Number: 9-79

Subject: Cylinder Head Gasket

Models: T140

SERVICE BULLETIN

METAL CENTER TOWARDS CYLINDER HEAD

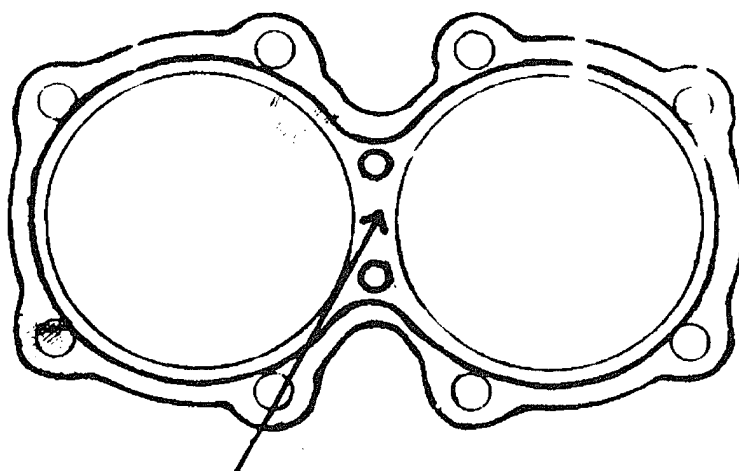
- 1) Ensure gasket is fitted correct way up, i.e. metal center towards cylinder head.

Cylinder head bolt tightening sequence

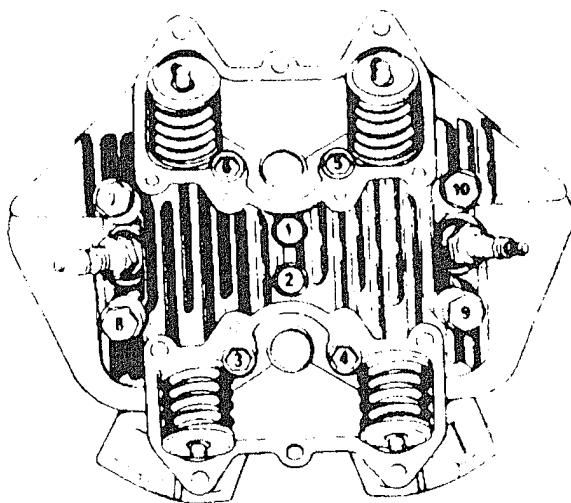
To enable retorque to be accomplished swiftly a service tool has been produced which drops through the rocker box fixing bolt holes and is available from the Triumph Parts Department. Part No. 61-7010.

61-7010. Sleeve nut adapter tool—cylinder head
